REMARKS

This is intended as a full and complete response to the Office Action dated June 25, 2007, having a shortened statutory period for response set to expire on September 25, 2007. Please reconsider the claims pending in the application for reasons discussed below.

FIG. 8

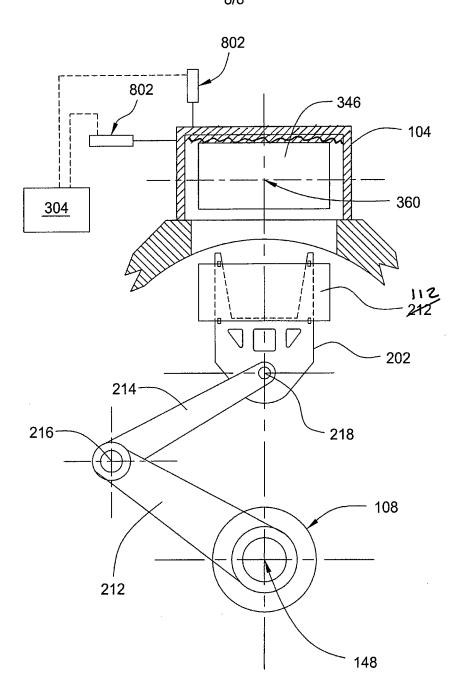
The attached sheet of drawings includes changes to Fig. 8. This sheet replaces the original sheet including Fig. 8. In Fig. 8, 212 has been replaced by 112 to correspond with the specification. Additionally, a minor editorial error regarding cross hatching of item 104 has been corrected.

In amended Figure 8, 212 has been replaced by 112 to correspond with the specification. Additionally, a minor editorial error regarding cross hatching of item 104 has been corrected.
